City of Portland, Maine - Bu	uilding or Use Permi	Permit No:	Date Applied For:	CBL:	
389 Congress Street, 04101 Tel	: (207) 874-8703, Fax:	(207) 874-871 <u>6</u>	05-0306	0312212005	091 A003001
Location of Construction:	Owner Name:	0	wner Address:		Phone:
0 Tolman Rd	Douglas Mary		154 Marlborough A	Ave	
Business Name:	Contractor Yame:	C	ontractor Address:		Phone
	Bill Bunton	8	87 Middle Road C	umberland	(207) 774-0111
Lessee/Buyer's Name	Phone:	P	ermit Type:		
			Single Family		
Proposed Use:	ļ.	Proposed	<b>Project Description:</b>		
Single Family Home/ 1200 sq ft 2	1200 sc	1200 sq ft 2 bedroom 1 1/2 story SFH			
	·	-			~ — -

**Douglas Cottage** Tolman Heights Peaks Island, Maine

### **ADDENDA #1**

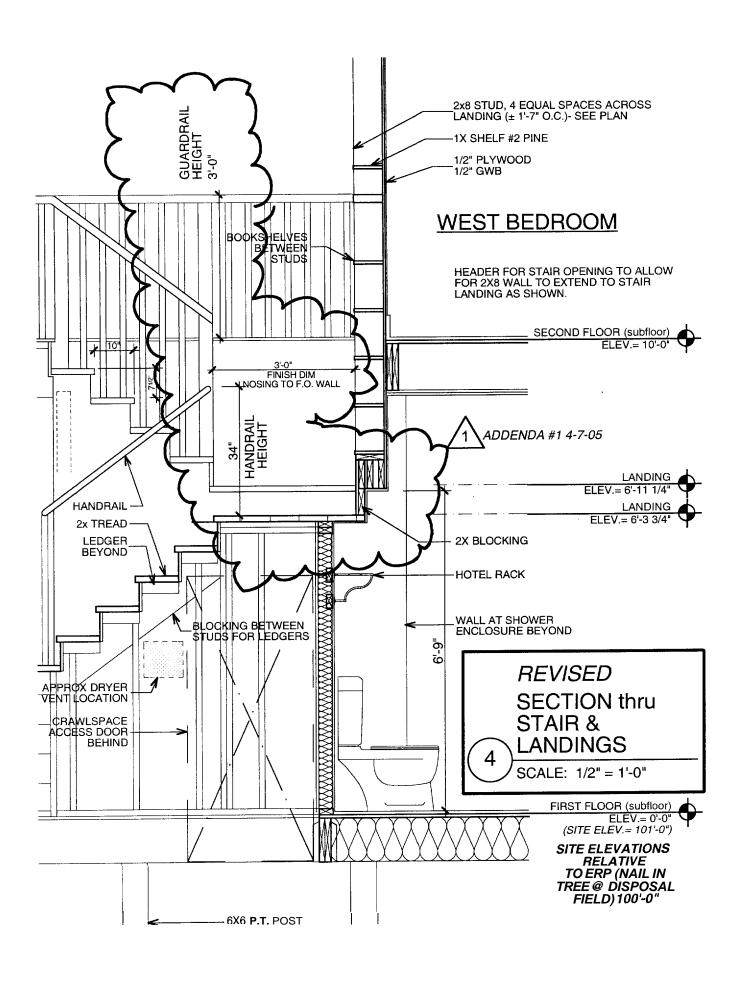
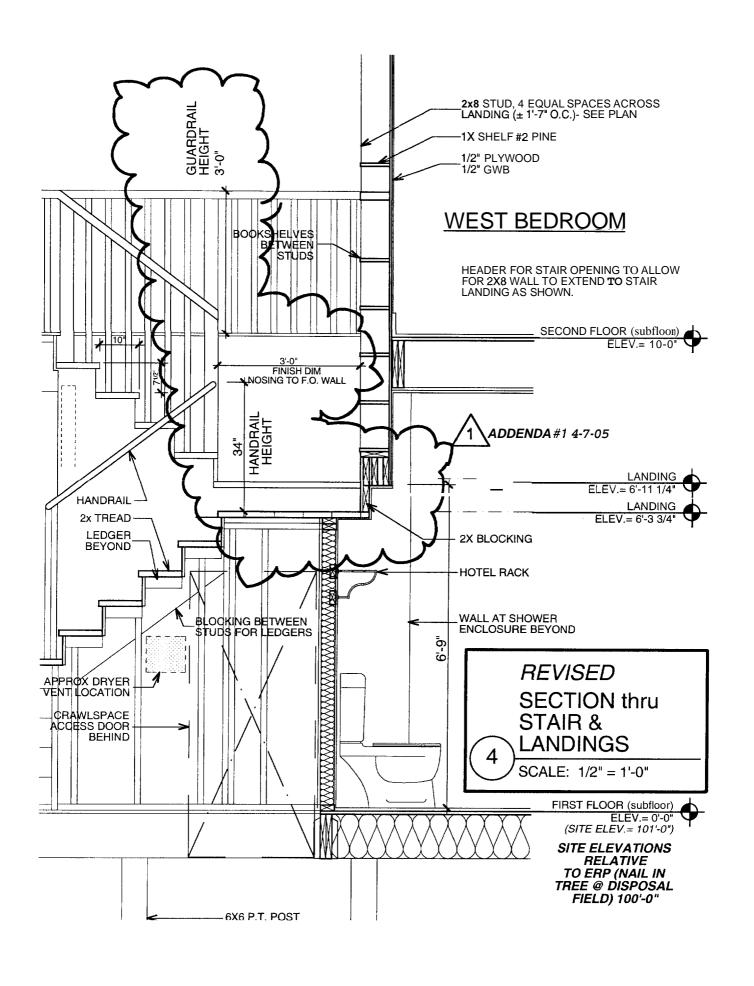
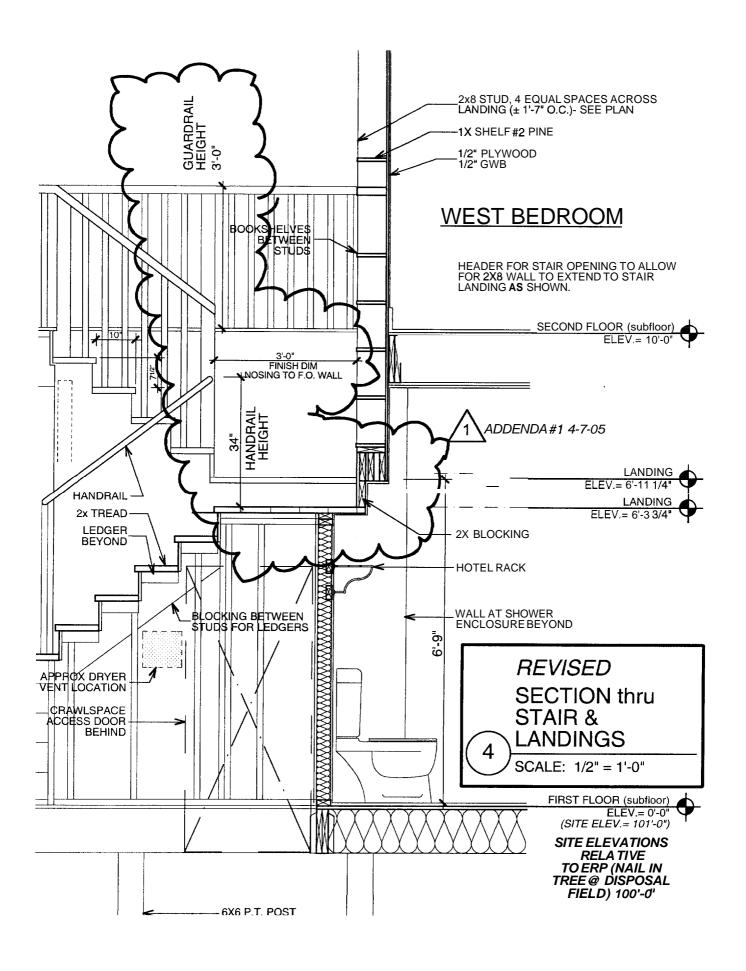
Railing Height: Railing indicated to be 36" AFF. See attached drawing "Revised Section thru Stair & Landings."

<u>Clearance at Toilet</u>: Headroom increased at toilet. Clearance is 6'-1" above the tank, 6'-9" between face of tank and rear edge of the toilet seat, and 8'-9" for the remainder of the fixture. See attached drawing "Revised Section thru Stair & Landings."

# Model 106, 106L, 106S Foundation Vents

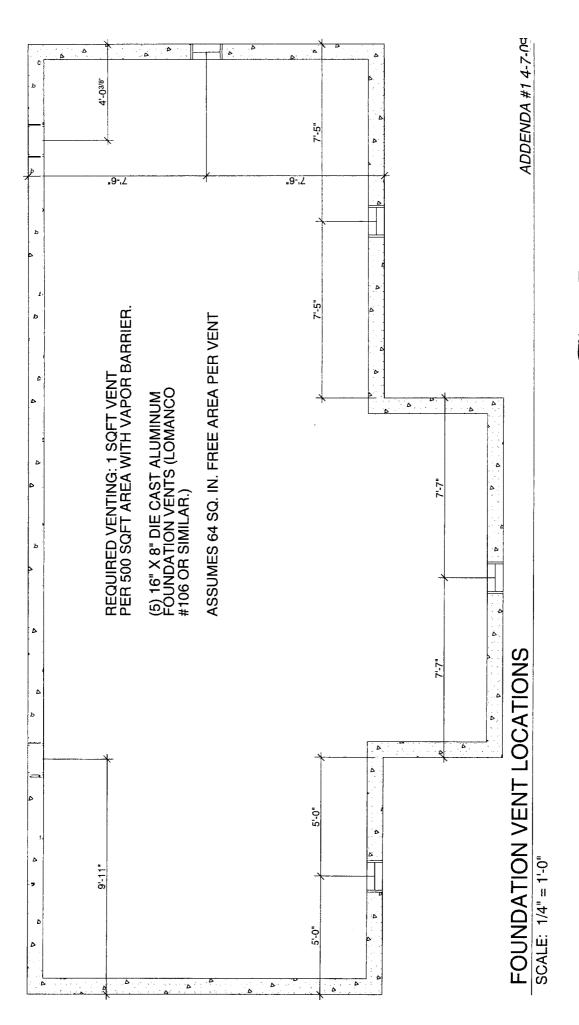
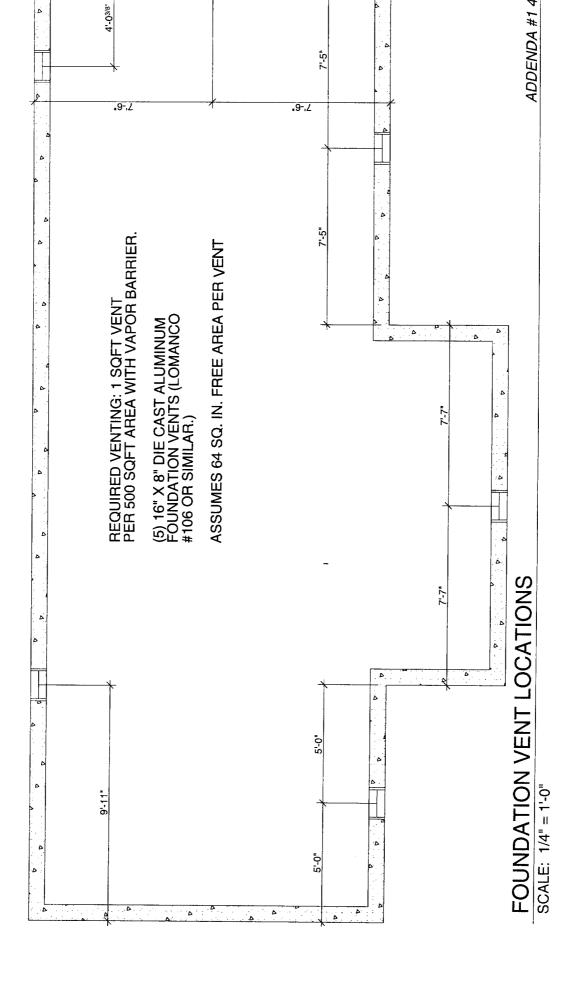
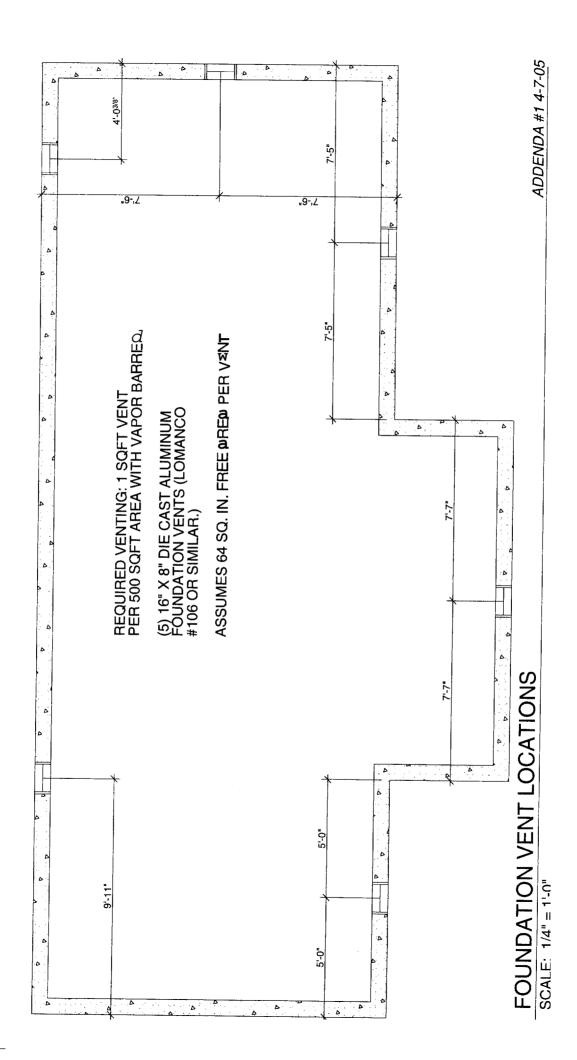
<u>Crawlspace Vents</u>: See attached plan "Foundation Vent Locations" for locations and description of venting.

288 SQIN = 5 LOUVERS
